VILLAGE OF MONROE

Workshop Minutes

Site Plan Review – Proposed addition / Condos

581 Route 17M - Monroe Pharm Plaza Condo (220-5-16.312)

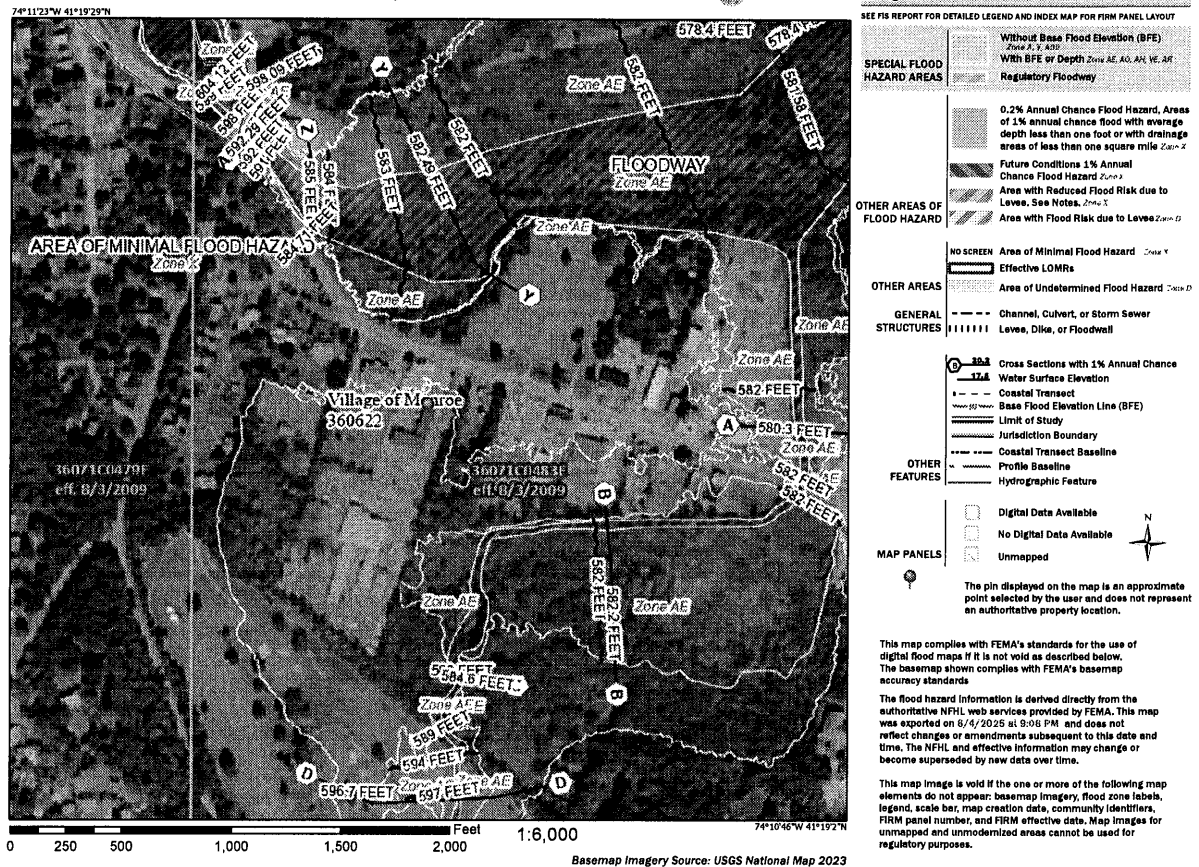
6. Section 200-32 of the Zoning Law provides requirements for a tree and landscaping plan including planting requirements at 200-32F. The landscape planting requirements are most applicable since the site has little if any existing vegetation. Sheets 4 and 5 provide for "Landscaping and Lighting Plan" and for "Landscape rendering" respectively. Both sheets should be updated to comply with the requirements of Subsection F. In addition, Sheet 4 shows a Plant List that includes 4 Red Maple and 3 Honeylocust. I was unable to locate anywhere on the site where these seven trees were

proposed for planting.

Parking adjoining residential properties must provide a living screen of double rows of evergreens staggered eight feet on center with six feet between rows and at least six feet in height at planting and capable of reaching ten feet within three years are required by § 200-34.F(1). The site abuts the Village's Urban Residential Multi-family (UR-M) Zoning District to the south. Although the site located south of the site does not appear to currently be used for residential purposes, it is located in an adjoining residential district where a variety of residential and compatible uses are permitted; the use appears to be a pre-existing non-conforming use. The Planning Board is empowered by § 200-34.A(8) to: *"Impose such additional restrictions and conditions on the location of parking spaces, outdoor lighting, landscaping and/or fencing to screen the nonresidential use from adjacent residential properties, and other conditions as, in the judgment of the Board, are necessary for the nonresidential use to be able to operate in a manner that is consistent with public safety and neighborhood character."*
